Addendum #2

Bid Opportunity: 23-7362-RFT

**Waterloo-Oxford District Secondary School –
Family Studies Renovation & HVAC Upgrades**

A3.1R

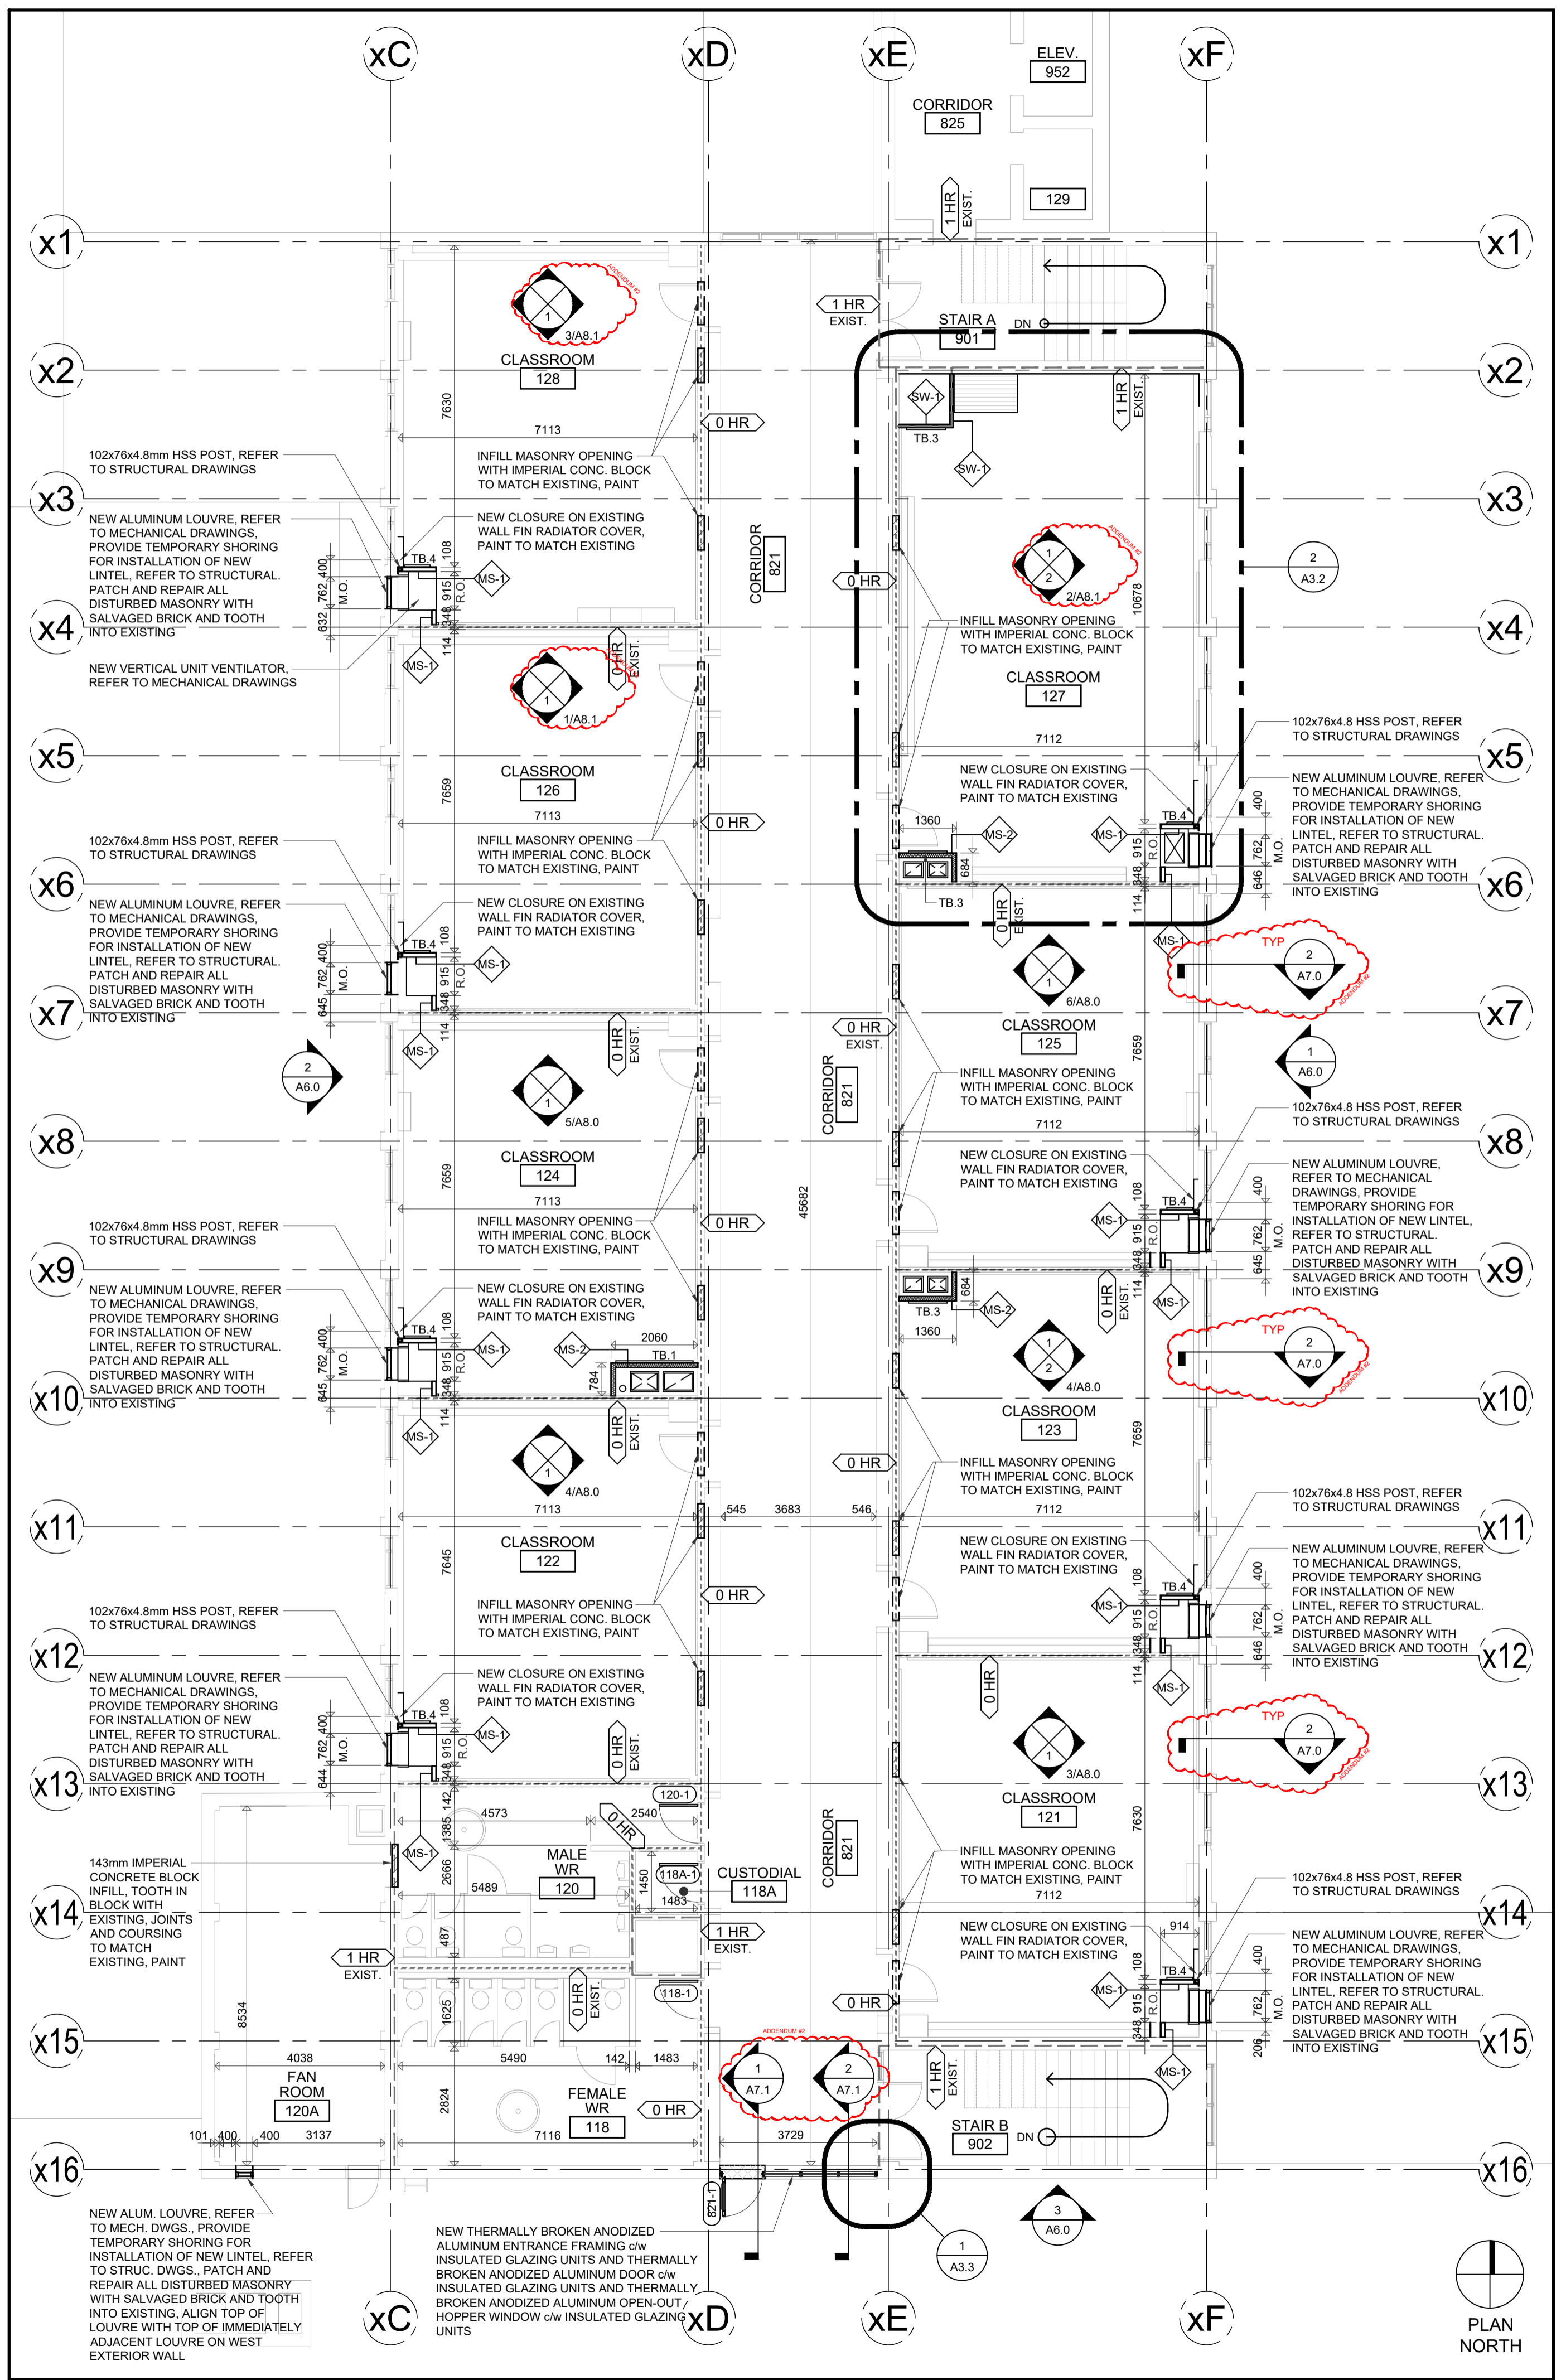
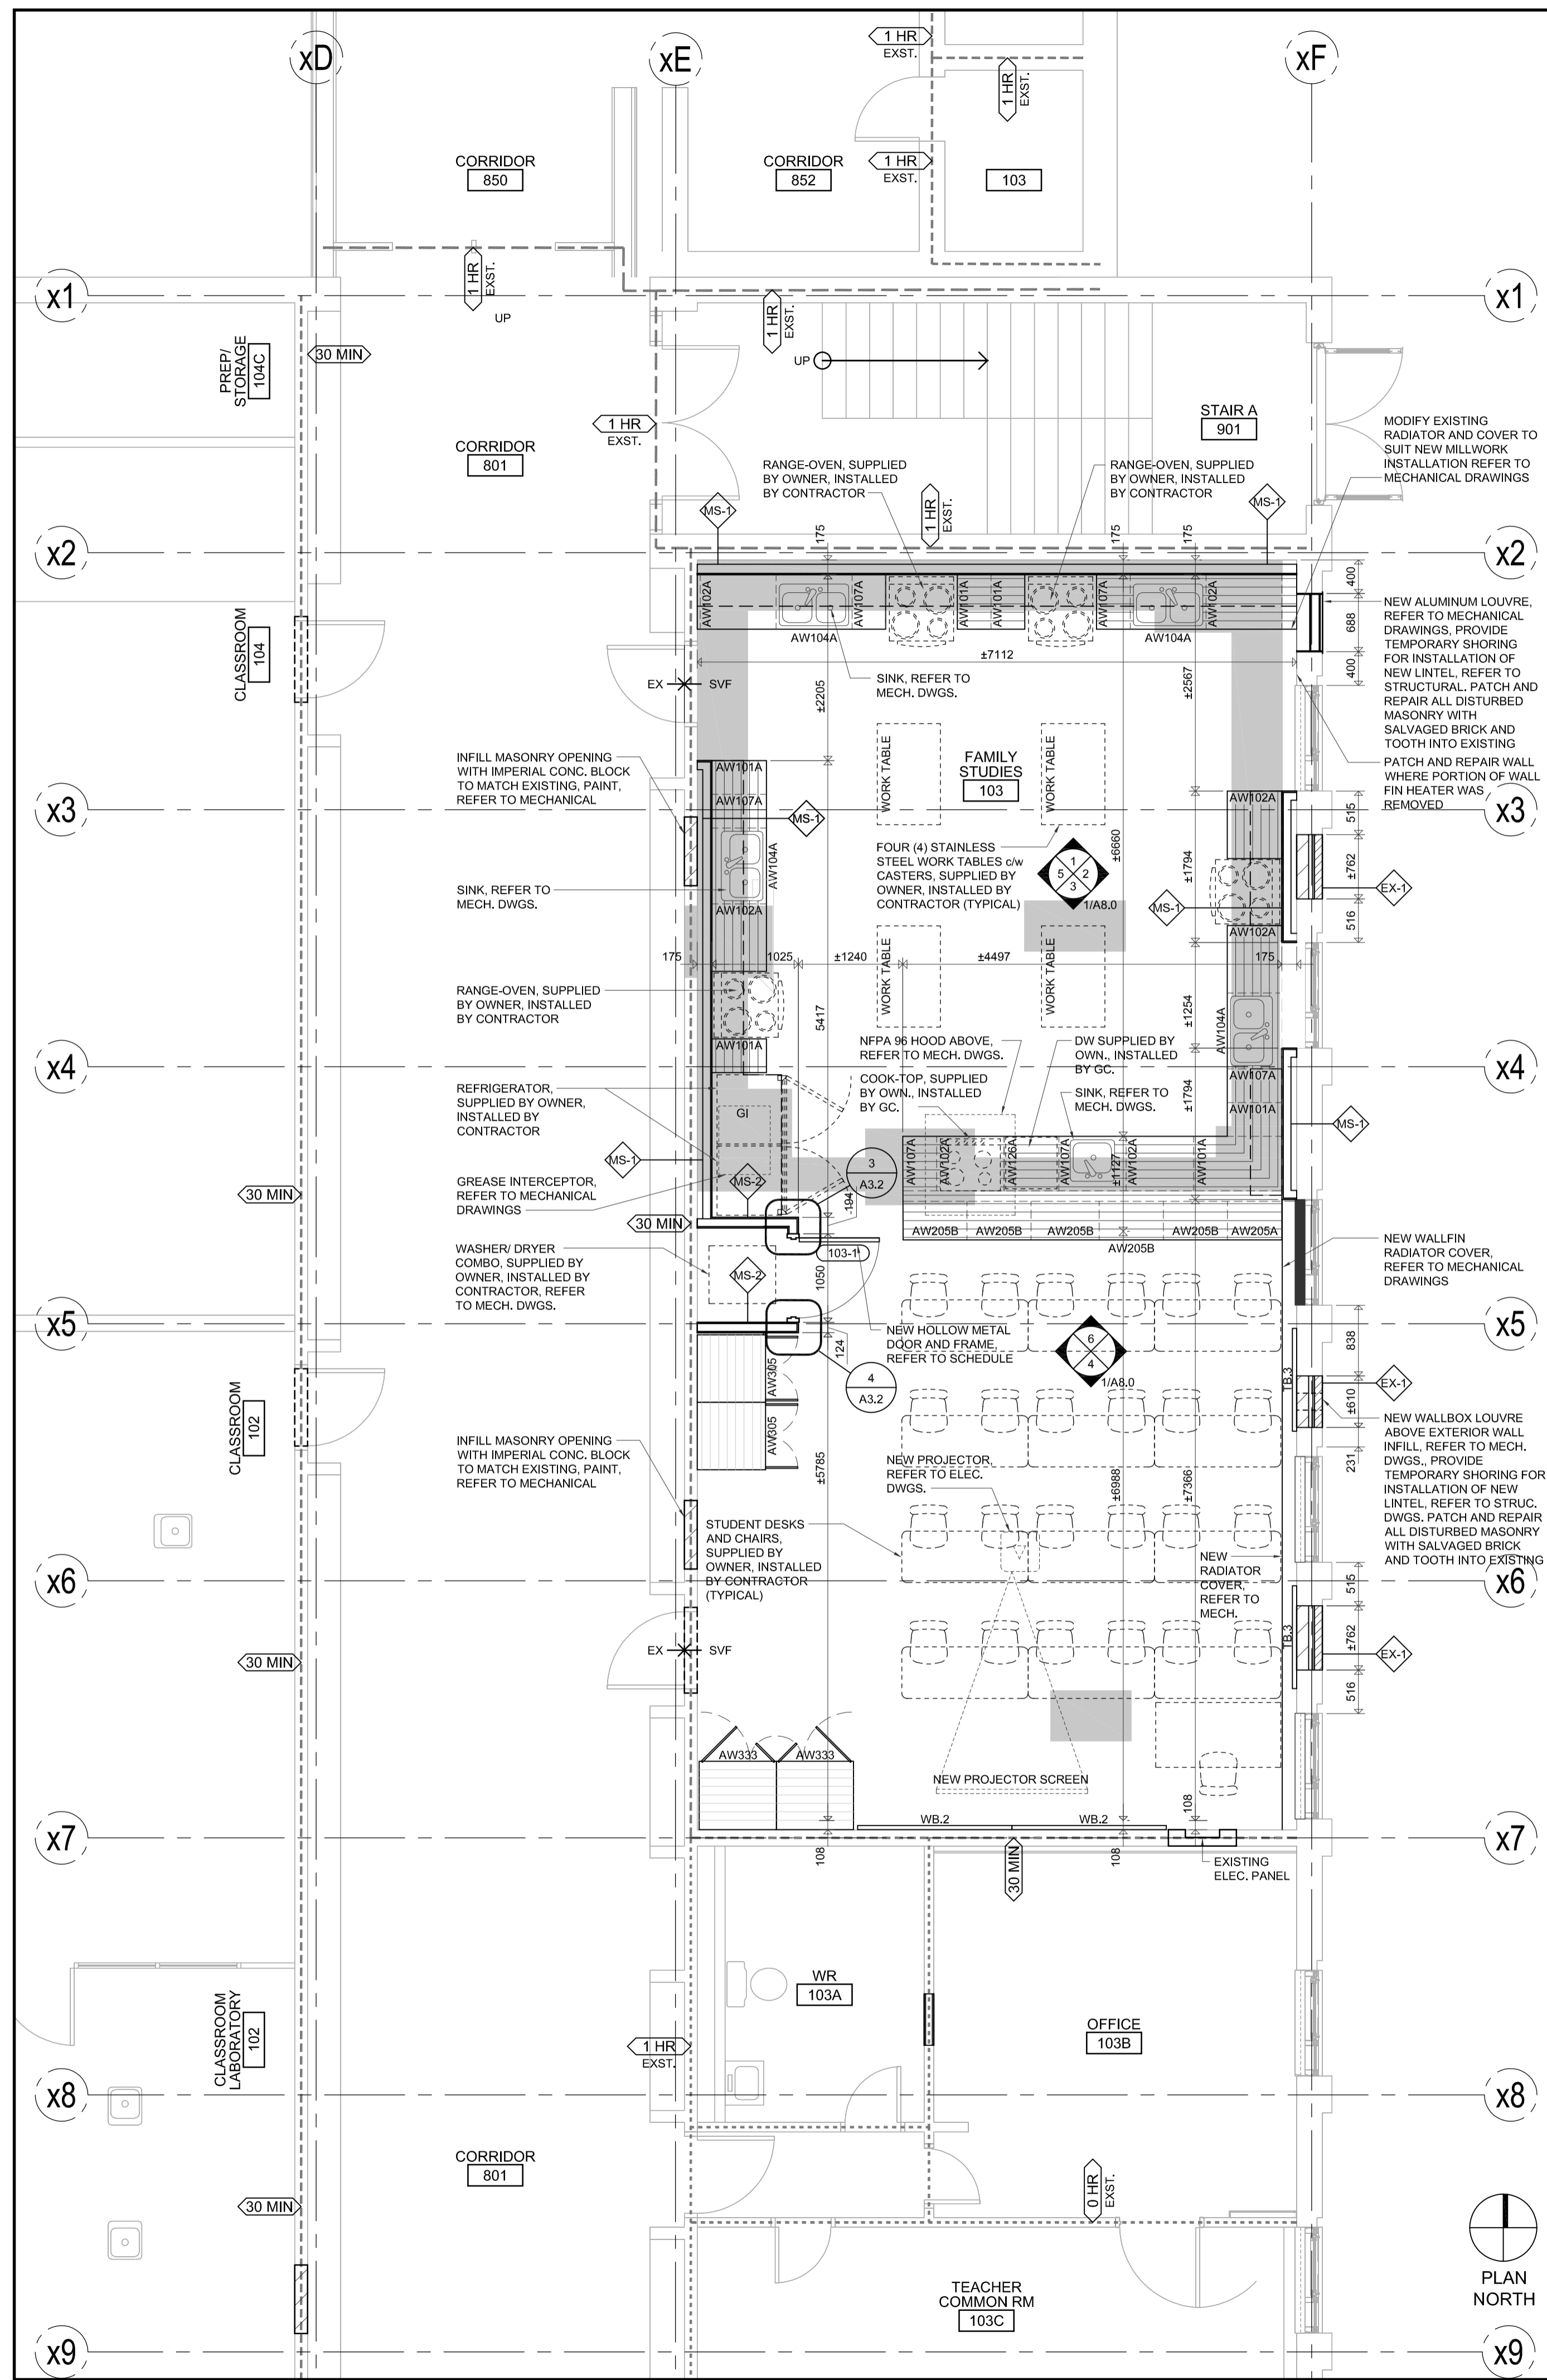
As per drawing A3.1, Section of wall adjacent to Grid X16 - xD is shown on drawing A6.1 section 1 but there is no such drawing. There is a section shown on Drawing A7.0 section 1, please confirm if the detail shown on drawing A7.0 is of the same location, if not please can you issue drawing A6.1

4. Drawing A2.1 Partial Demolition Floor Plans
 1. **REPLACE DRAWING A2.1 WITH DRAWING A2.1R, ATTACHED. DETAIL REFERENCES HAVE BEEN ADDED/ REVISED.**
5. Drawing A2.3 Partial Reflected Ceiling Demolition Plans
 1. **REPLACE DRAWING A2.3 WITH DRAWING A2.3R, ATTACHED. SCOPE OF WORK IN FAMILY STUDIES 103 HAS BEEN REVISED.**
6. Drawing A3.1 Partial Floor Plans
 1. **REPLACE DRAWING A3.1 WITH DRAWING A3.1R, ATTACHED. DETAIL REFERENCES HAVE BEEN ADDED/ REVISED.**
